Our Ref: 20168 LPA2 GC

30th April 2021

PP/21/01425 Demolition of existing building and redevelopment for new building up to five storeys (Use Class E); basement excavation works; creation of a courtyard area at ground and lower ground levels; roof terraces; landscaping works; installation of plant; and associated works. (MAJOR APPLICATION) at 81-103 (odd) King's Road, LONDON, SW3 4NX

**Appendix 1** Drawing no. 20168(ALL)01-A 'ELEVATION COMPARISON STUDY'

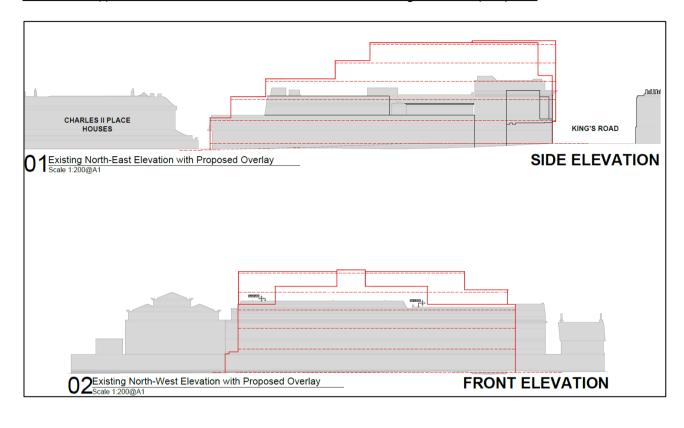
Drawing number 20168(ALL)01-A 'ELEVATION COMPARISON STUDY' provides further justification to the submitted objection on behalf of the Board of CIIP. It provides evidence of the overbearing and dominating adverse impact of the proposal, due to the height, scale and massing of the proposed building. The new building is clearly out of character with, will visually dominate, and have an unacceptable overbearing impact on the neighbouring CIIP houses, harmfully increasing the sense of enclosure to these existing houses and their gardens. It will also appear out of character and scale with the existing street scene of the King's Road.

this substantial redevelopment proposal will cause significant adverse impact on the CIIP occupiers' residential amenity due to its height, scale, massing, bulk, over-development and proximity to their properties, resulting in loss of privacy, overshadowing, loss of daylight and an overbearing/over-dominant detrimental impact on current standards of amenity. Buildings, servicing, and general activity will be introduced close to the boundary with their houses, with the potential for unacceptable nuisance and noise disturbance. Furthermore, the proposed 4 storey element of the scheme facing onto nos. 1-3 CIIP and next to no. 51 CIIP, with facing windows in these floors, will have a dominating and overbearing impact, which will also create a sense of being overlooked.
